DOCKETS 50-266 AND 50-301
SUPPLEMENT TO
TECHNICAL SPECIFICATIONS CHANGE REQUEST 192
POINT BEACH NUCLEAR PLANT, UNITS 1 AND 2

TECHNICAL SPECIFICATION CHANGE REQUEST 192
RESPONSE TO REQUEST FOR ADDITIONAL INFORMATION

POST-LOCA CONTAINMENT PRESSURE RESPONSE

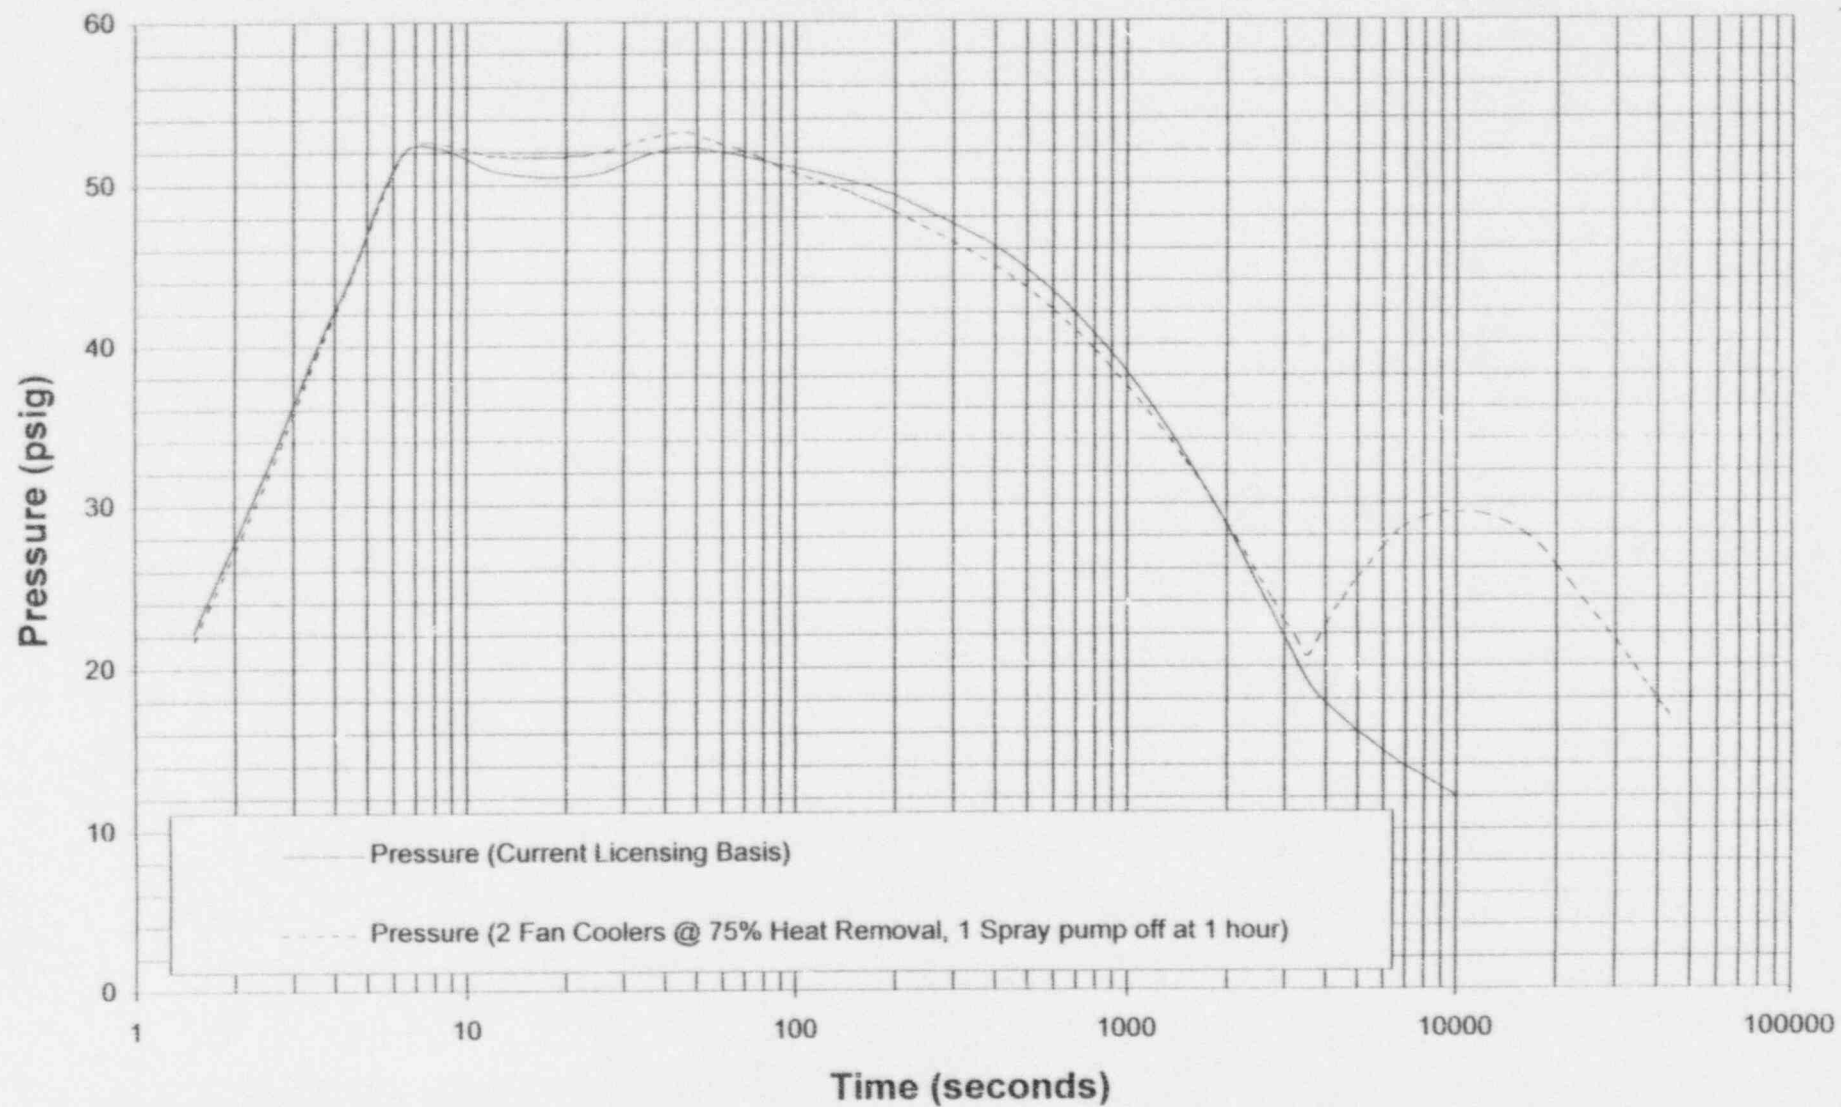
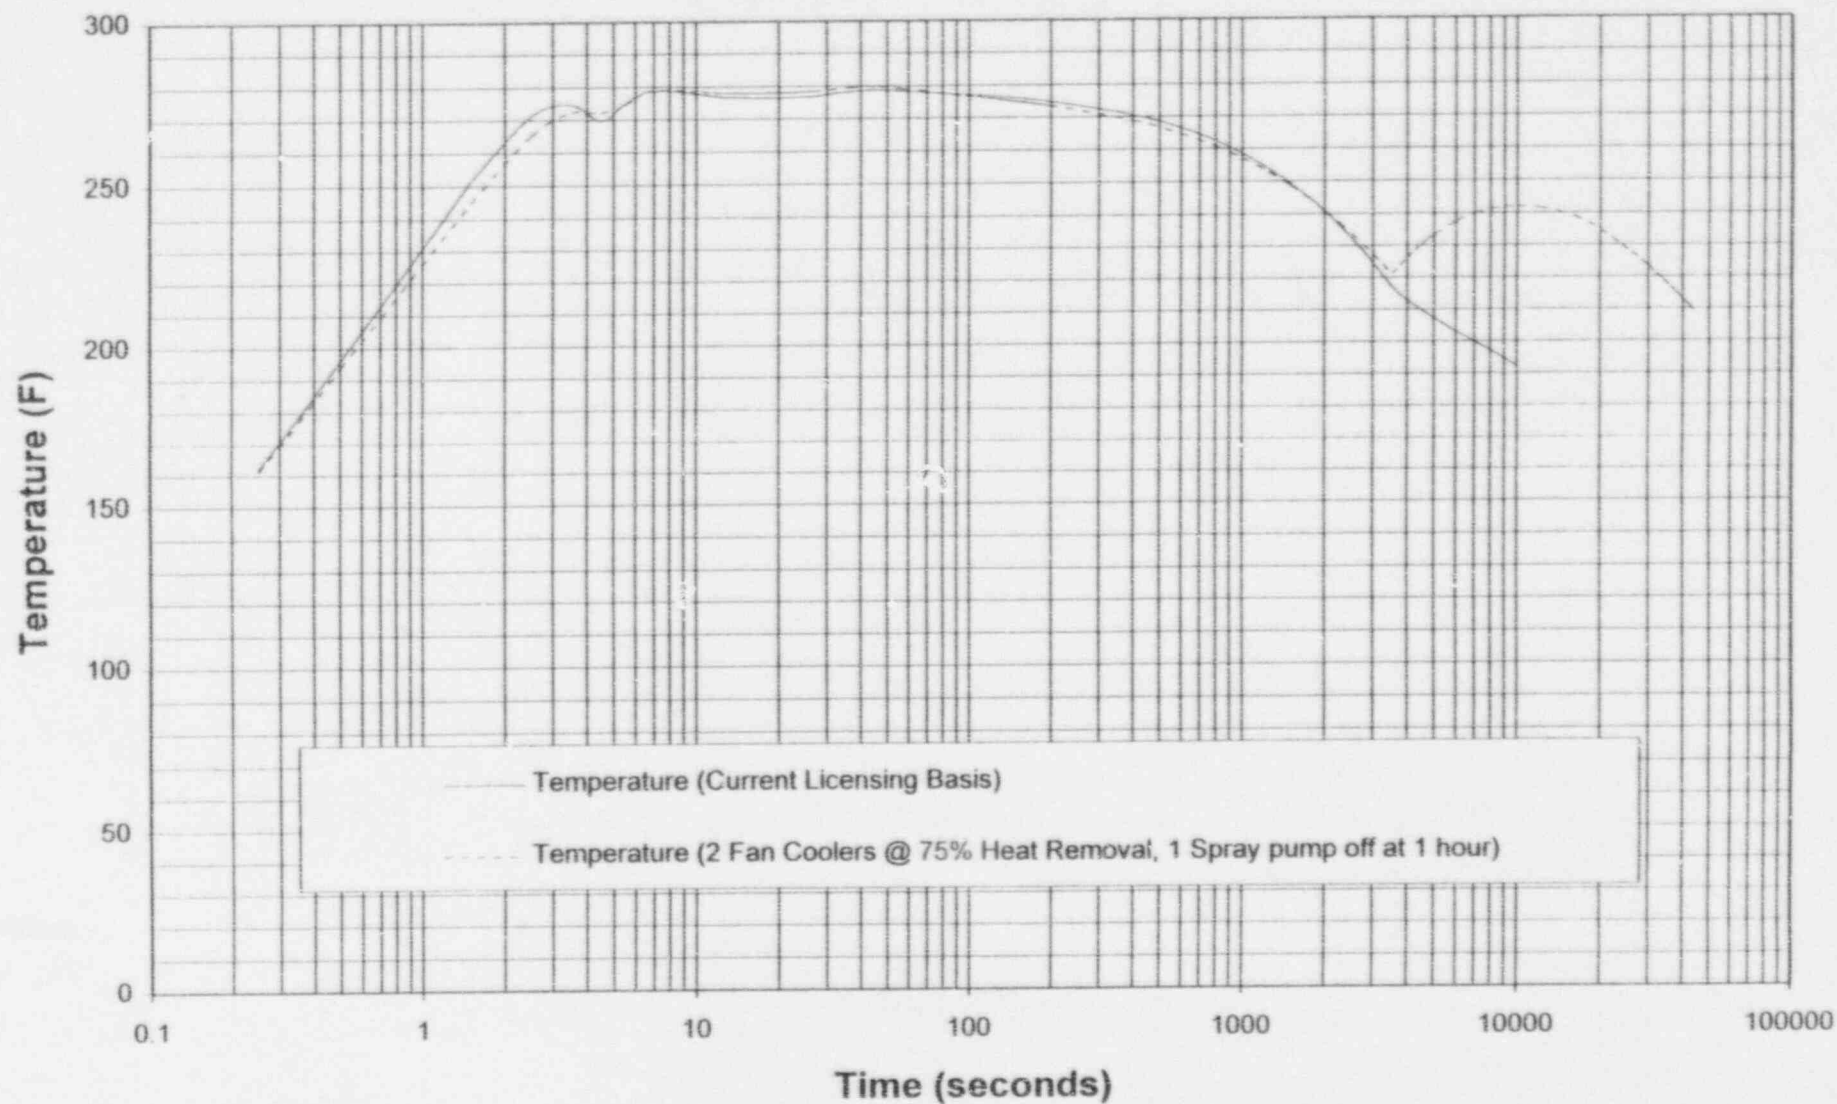
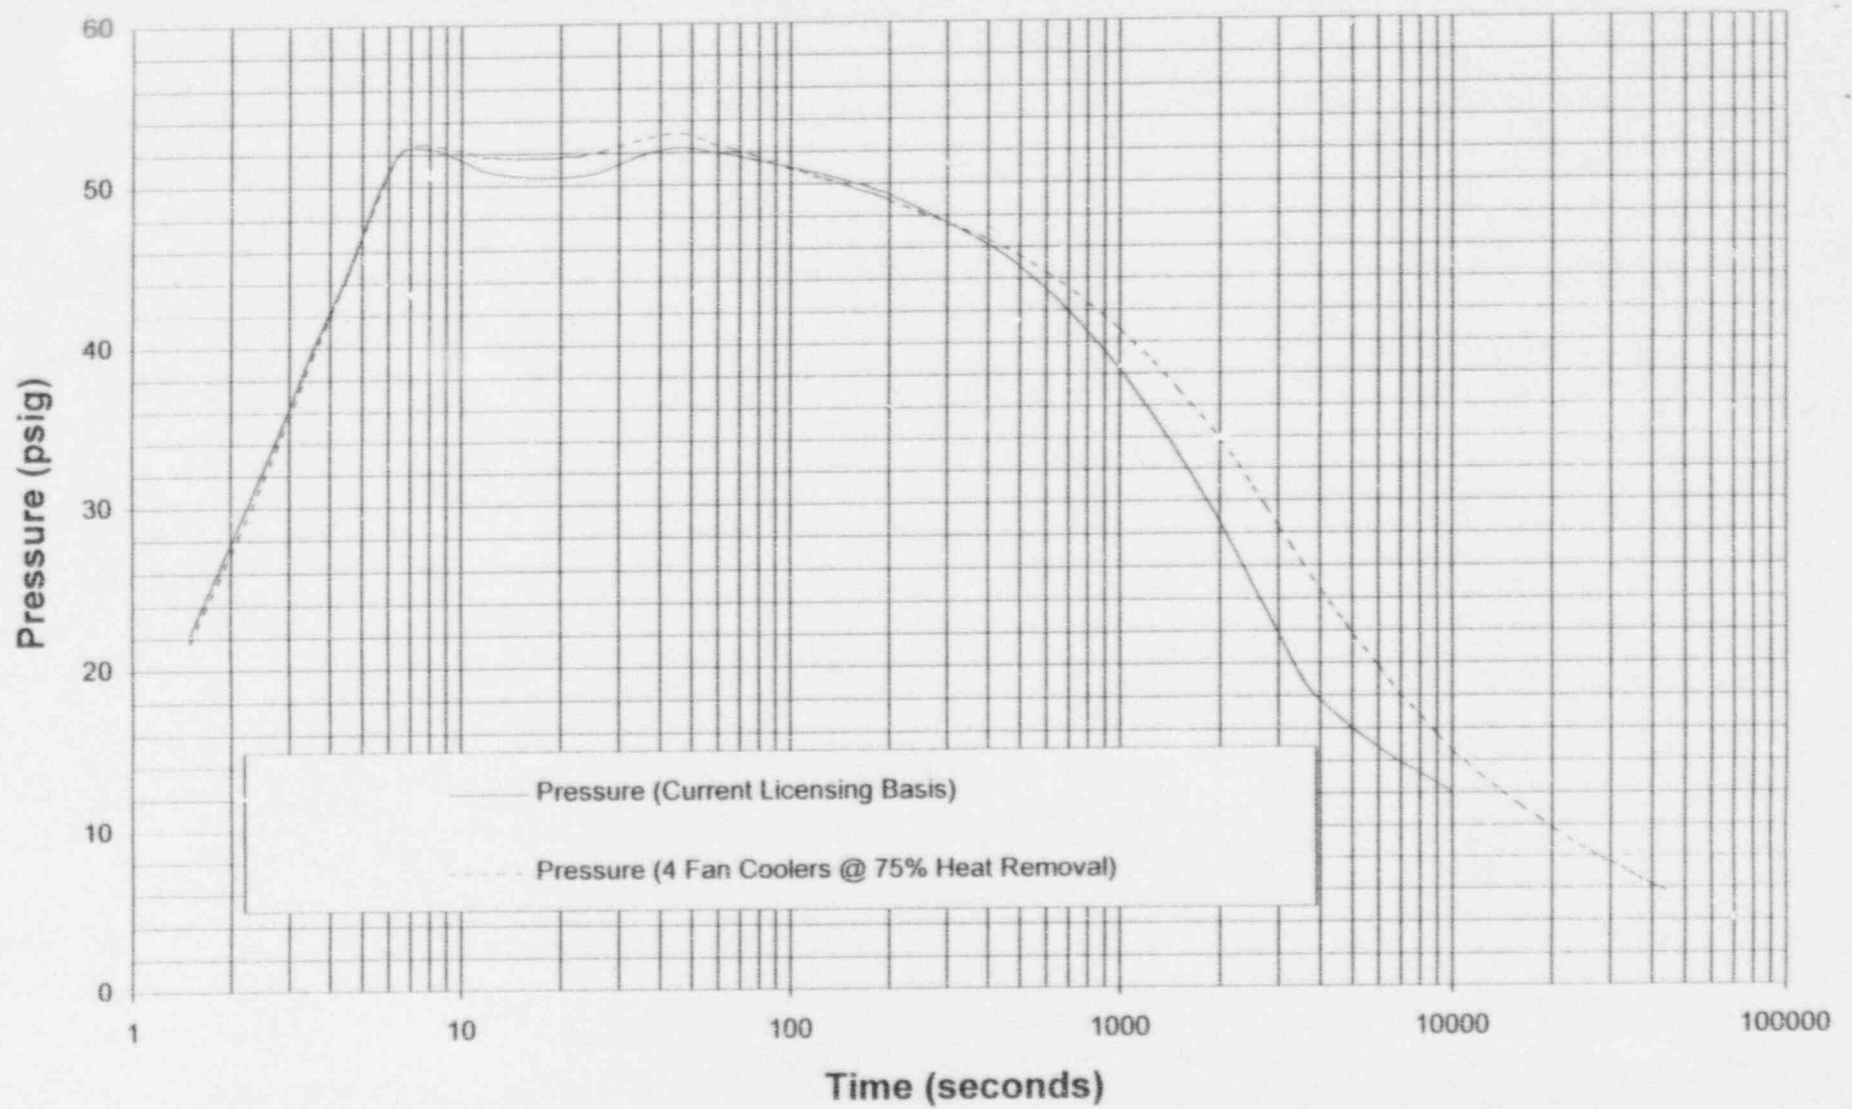
1. Attachment 3 indicates that Westinghouse performed a new post-LOCA containment pressure and temperature analysis in 1996. Do the mass and energy boundary conditions and the containment response model for the 1996 analysis reflect any and all post-Operating License plant modifications that might affect the containment pressure and temperature response to a loss-of-coolant accident? Will the 1996 analysis be incorporated into the Final Safety Analysis Report as the new analysis of record?

Analysis of the combined effect of the containment fan cooler heat removal rate reduction and the steam generator replacement has been performed. The results show that the containment design pressure is not exceeded and that containment heat removal is sufficient to prevent overpressurization of the containment. The attached figures show the resultant containment pressure and temperature response. The results show that the steam generator replacement causes a slightly higher peak

containment pressure, similar to that predicted by the steam generator replacement evaluation. Therefore, with respect to the containment integrity analysis, the effect of the steam generator replacement, combined with all other changes to the plant since the original analysis, is minor.
